Re: **CANYON POWER PLANT'S  
DATA RESPONSES TO DATA REQUESTS 1 - 55  
DOCKET NO. 07-AFC-9**

APPLICATION FOR CERTIFICATION  
For the *CANYON POWER PLANT*  
PROJECT

Docket No. 07-AFC-9

**CANYON POWER PLANT  
APPLICATION FOR CERTIFICATION  
RESPONSE TO CEC DATA REQUESTS  
07-AFC-9**

**FIGURE 3  
AREAS OF TPH IMPACTED SOILS (>1,000 MG/KG)**

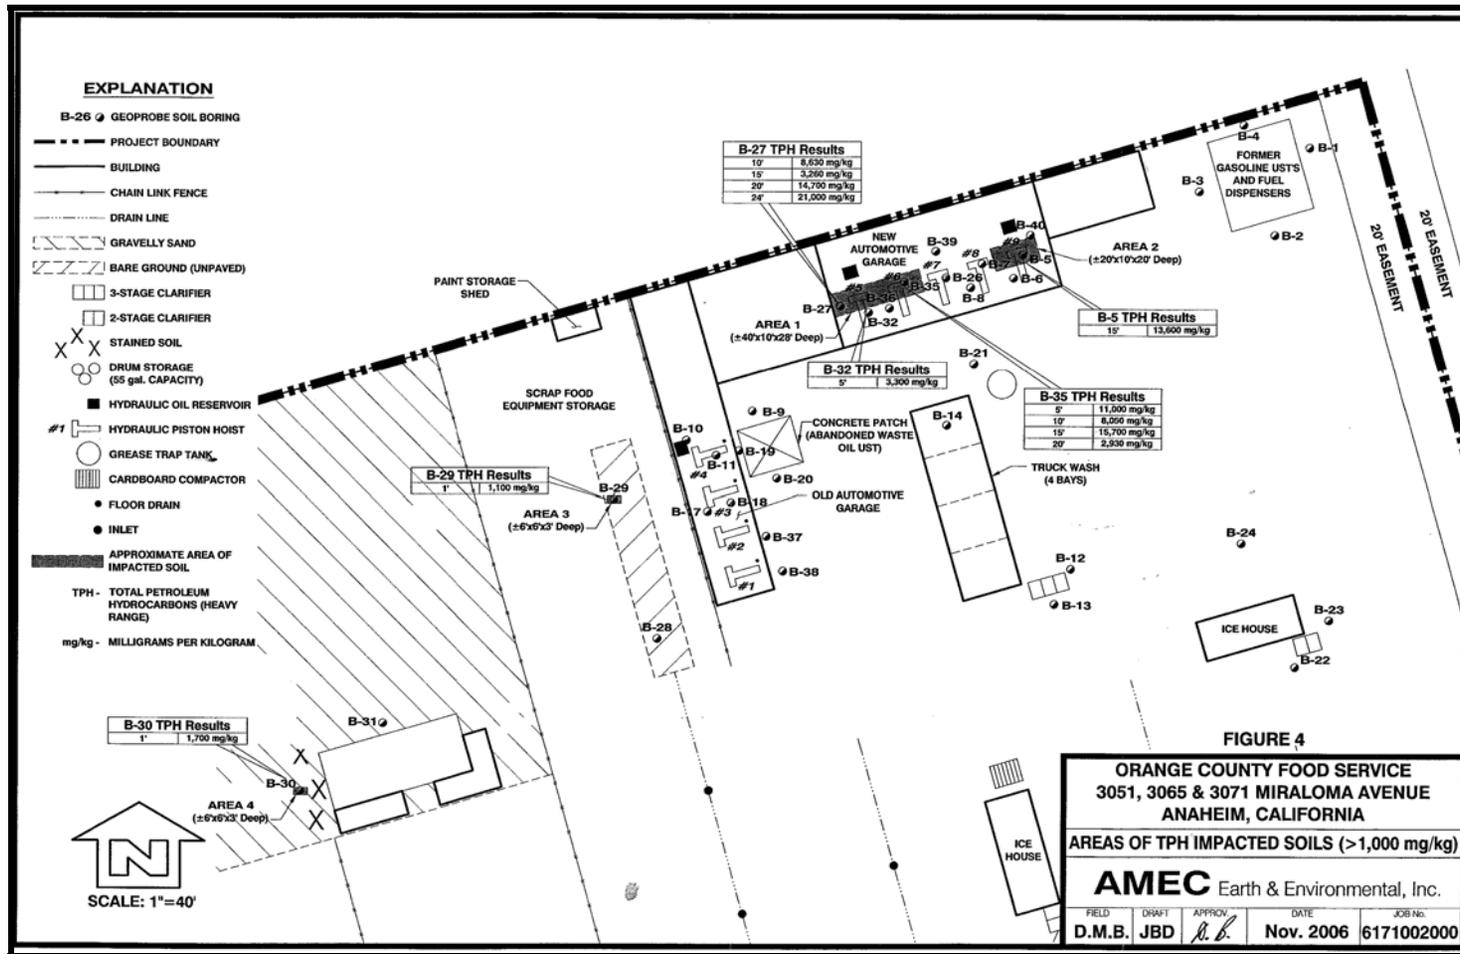
**Data Request 12-CUL:** Please describe all planned soil remediation activities on the proposed site and include:

Based on findings from the Phase II ESA, the site contains three areas that will be excavated and meet the generally accepted level of 1,000 mg/kg for TPH heavier-range compounds. These areas are located in the northern portion of the site where the former automotive garage operations occurred. The TPH impacted areas are identified in Figure 3 as Area 1, Area 2, and Area 3. Soil remediation activities for each area will consist of the following:

Quantities of extant artificial fill and native alluvium soils that will be removed from the site will range from 10,800 ft<sup>3</sup> to 11,200 ft<sup>3</sup>, depending on the area of excavation. The Canyon Power Plant site is located in the alluvial plain of the Santa Ana River and its near-surface soils (consisting of artificial fill) extends from one to two feet in depth. Areas impacted with petroleum hydrocarbons will include the removal of all artificial fill and native alluvial soil to a depth of 28 feet (for Area 1), 20 feet (for Area 2), and 3 feet (for Area 3). Removal of artificial fill and native alluvial soils in areas with lead impacted soils are anticipated to be to a maximum depth of 3 feet. The actual depth of excavation for any of the impacted areas will be based on the cleanup level agreed to with the lead agency and field conditions encountered during excavation, which will ultimately determine the amounts of artificial fill and native alluvium soil that will be removed from the site. The COA will develop a soil management plan prior to commencement of excavation and/or soil remediation activities to define the absolute quantities of artificial fill and native alluvium that will be removed form the site. See Figure 3.
